Project	IEEE 802.16 Broadband Wireless Access Working Group < http://ieee802.org/16 >
Title	Flexible Frequency Reuse Operation
Date Submitted	2004-07-08
Source(s)	Jeong-Heon Kim, Panyuh Joo, Seung Joo Maeng, Jaeho Jeon, Soon Young Yoon Samsung Electronics Co., Ltd. jeongheon.kim@samsung.com
Re:	Contribution supporting Sponsor ballot
Abstract	Frequency reuse factor of 1 and non-one frequency reuse factor support at the same time
Purpose	Adoption of suggested changes into P802.16e/D3
Notice	This document has been prepared to assist IEEE 802.16. It is offered as a basis for discussion and is not binding on the contributing individual(s) or organization(s). The material in this document is subject to change in form and content after further study. The contributor(s) reserve(s) the right to add, amend or withdraw material contained herein.
Release	The contributor grants a free, irrevocable license to the IEEE to incorporate material contained in this contribution, and any modifications thereof, in the creation of an IEEE Standards publication; to copyright in the IEEE's name any IEEE Standards publication even though it may include portions of this contribution; and at the IEEE's sole d

Figure 1 structure of downlink/uplink when type I scheme is applied

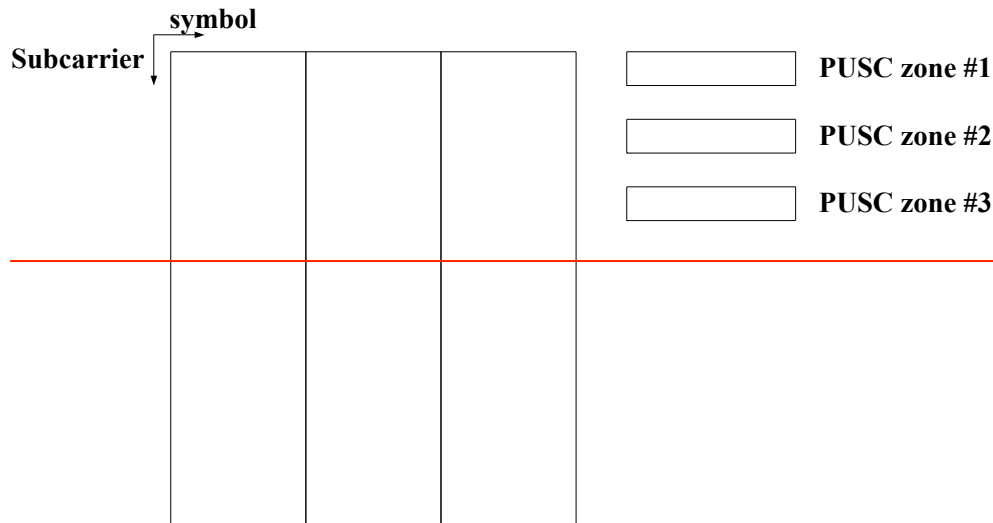
8.4.6.1.2.4 Additional optional symbol structure for PUSC type I

Subcarrier allocation for PUSC type I is depicted in Figure 1. Each PUSC zone is allocated a disjoint set of symbols. In each PUSC zone, Subcarrier allocation is the same as optional FUSC in section 8.4.6.1.2.3 and the permutation formula in section 8.4.6.1.2.3.1 shall be used.

Figure 4 aaa Subcarrier allocation for PUSC type II

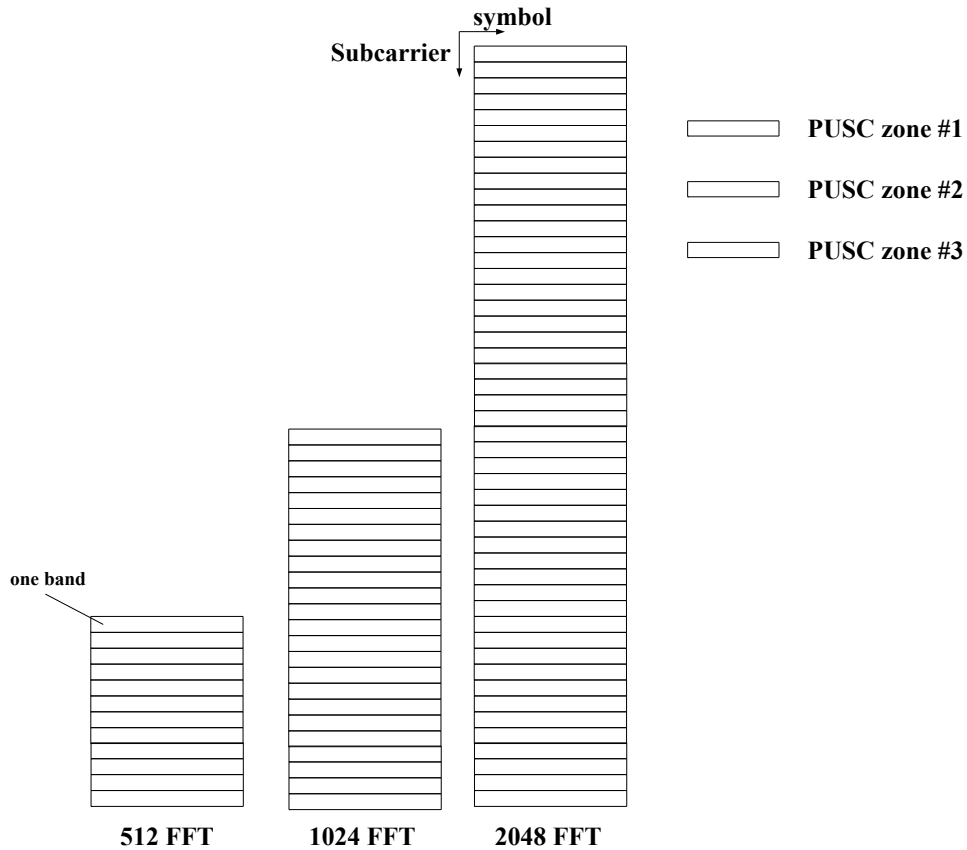
Subcarrier allocation for PUSC type II is depicted in Figure 4. A bunch of 9 contiguous subcarriers containing 1 pilot carrier and 8 data carriers is called a bin and 4 consecutive bins are called a band. Those bands are divided into three segments each of which is assigned to a PUSC zone.

For PUSC type II operation, total bands are partitioned into 3 segments and subchannel subcarrier allocation is done in each segment. The partition into 3 segments is shown in Figure 4. To allocate the diversity subchannels, data tones in 3 consecutive symbols in a segment are partitioned into 48 groups of contiguous data subcarriers. Each subchannel consists of one subcarrier from each of these groups. The exact partitioning into subchannels is according to the permutation formula in section 8.4.6.1.2.3.1. If FFT size is 512, then N_s is 8. If FFT size is 1024, then N_s is 16. If FFT size is 2048, then N_s is 32. The basic permutation sequences P_1 and P_2 are shown in Table 309a. The enumeration of the subcarriers in a segment within three symbols starts from the lowest numbered data subcarrier of the first symbol in a segment and goes to the next carriers. If it reaches the last carrier in the symbol in the segment, it goes to the lowest data carrier of the next symbol and so on.

Figure 5 subcarrier allocation for PUSC type III-A

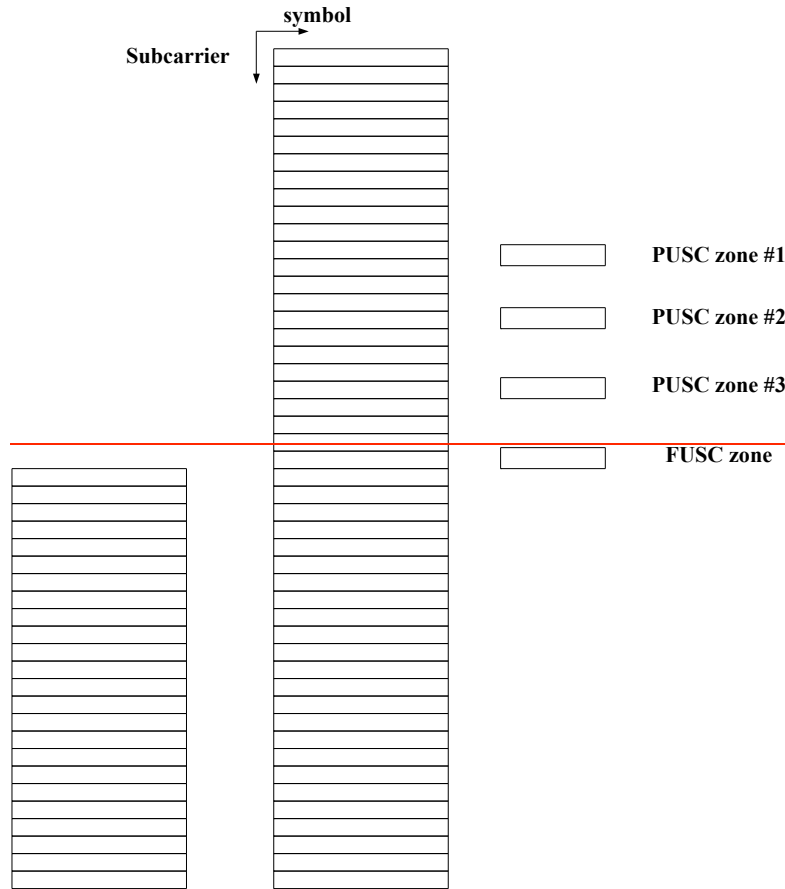
For 2048 FFT, N_{used} subcarriers are divided into 48 bands of contiguous subcarriers which are indexed from 0 to 47. Even numbered bands are used for FUSC and odd numbered bands are used for PUSC. 24 bands for PUSC are divided into 3 segments, which are used for different sectors respectively. The subcarrier allocation for FUSC + PUSC operation is described in Table 5. Similar subcarrier allocation for 1024 FFT is shown in Table 6.

Figure 6 Subcarrier allocation for PUSC type III-B in 1024 FFT

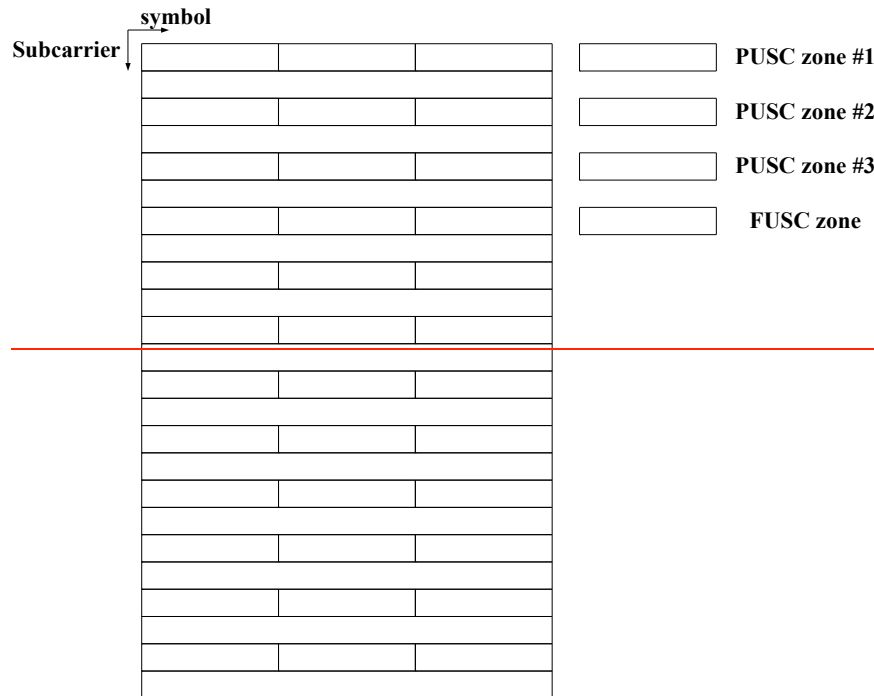
For 2048 FFT, N_{used} subcarriers are divided into 48 bands of contiguous subcarriers which are indexed from 0 to 47. Even numbered bands are used for FUSC zone and odd numbered bands are used for PUSC zone. The partition of subcarriers in three symbols is shown in Figure 6. The subcarrier allocation for PUSC type III-B operation is described in Table 11. Similar subcarrier allocation for 1024 FFT is shown in Table 12.
